SHA
STATE OF MARYLAND
DEPARTMENT OF TRANSPORTATION
STATE HIGHWAY ADMINISTRATION
OFFICE OF TRAFFIC & SAFETY
TRAFFIC ENGINEERING DESIGN DIVISION
MD 140 (Main Street) and MD 30 (Hanover Pike)
Reisterstown, Maryland

TRAFFIC SIGNALIZATION PLAN

TS NO. 435 E | DRAWING TSP-1 OF 3 | SHEET NO. 1 OF 3

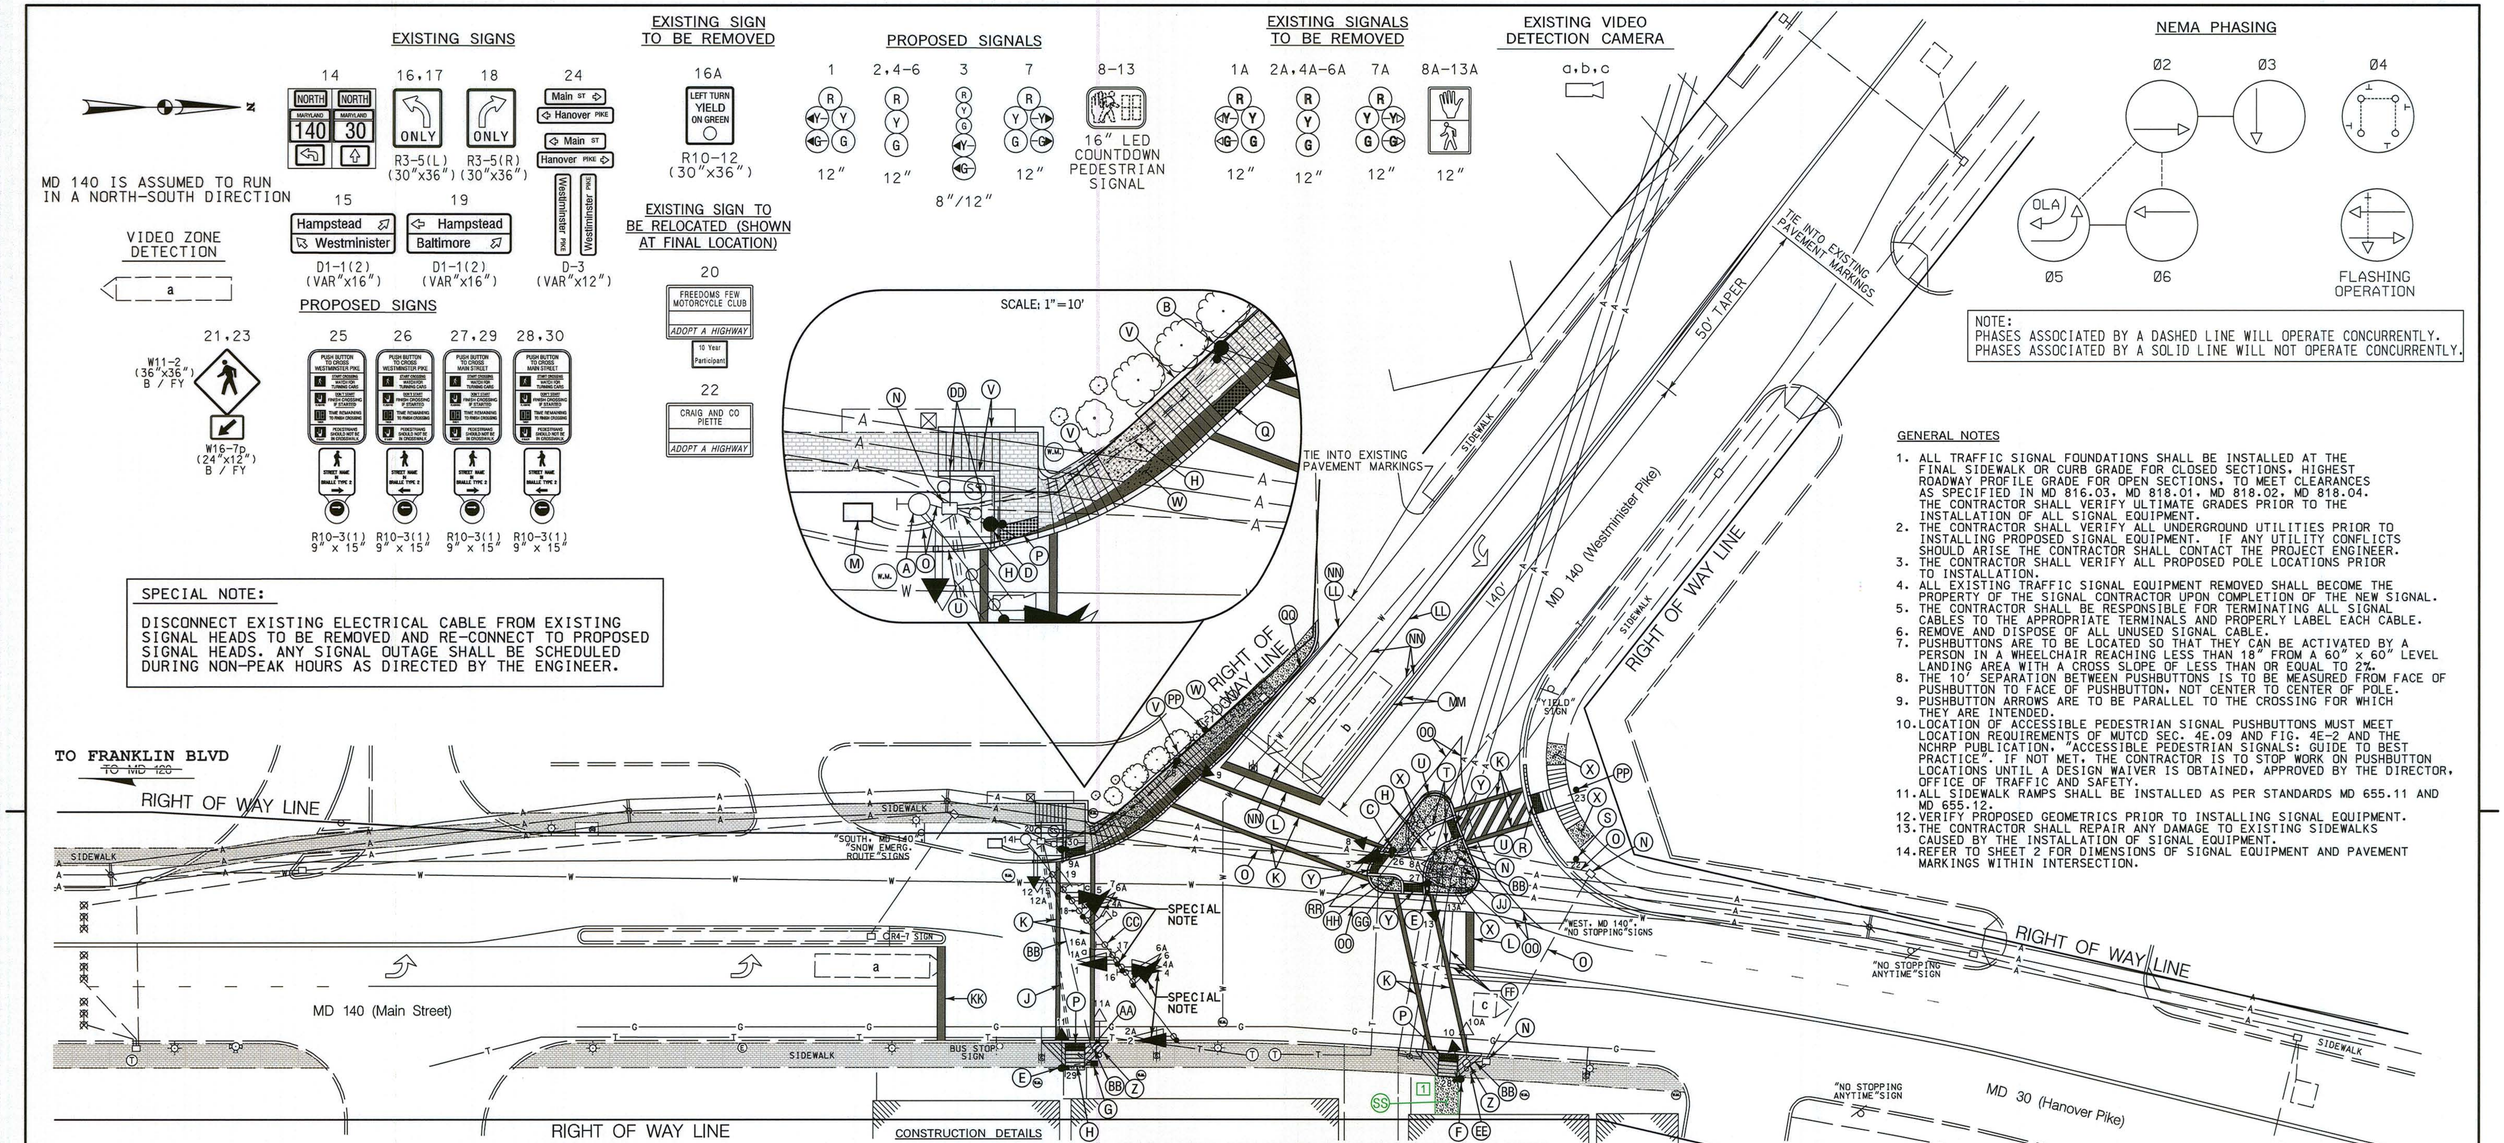
REVISIONS
[1] GREENLINE 1 - REVISED SE CORNER RAMP TO COMPLY WITH 48:1 ADA SLOPE REQUIREMENTS. SHA NO. XX6455185 1/11/2012 SRB NM
[F] INSTALLED APS/CPS AND UPGRADED SIDEWALK RAMPS. SHA NO. XX6455185 6/09/2011 SRB NM
[E] ASBUILT SHA NO. BW 996M82 2/22/1999 FJH

LL. INSTALL 5 IN. HEAT APPLIED, WHITE PERMANENT PREFORMED THERMOPLASTIC PAVEMENT MARKING.
MM. INSTALL 5 IN. HEAT APPLIED, YELLOW PERMANENT PREFORMED THERMOPLASTIC PAVEMENT MARKING.
NN. REMOVE EXISTING PAVEMENT MARKINGS IN CONFLICT WITH PROPOSED PAVEMENT MARKINGS.
OO. REMOVE EXISTING AND INSTALL 5 IN. HEAT APPLIED, WHITE PERMANENT PREFORMED THERMOPLASTIC PAVEMENT MARKING.
PP. INSTALL W11-2 (36"x36") B/FY AND W16-7p (24"x12") B/FY SIGNS ON ONE 4 IN. X 6 IN. TREATED WOOD SUPPORT (L=17') AS SHOWN.
QQ. INSTALL 5 IN. CONCRETE SIDEWALK AND COMBINATION CONCRETE CURB AND GUTTER (STANDARD NO. MD 620.02 TYPE 'A').
RR. INSTALL COMBINATION CONCRETE CURB AND GUTTER (STANDARD NO. MD 620.02 TYPE 'A').
[1] SS. REMOVE EXISTING SIDEWALK AND INSTALL 5 INCH CONCRETE SIDEWALK TO MEET 48:1 ADA SLOPE REQUIREMENTS.
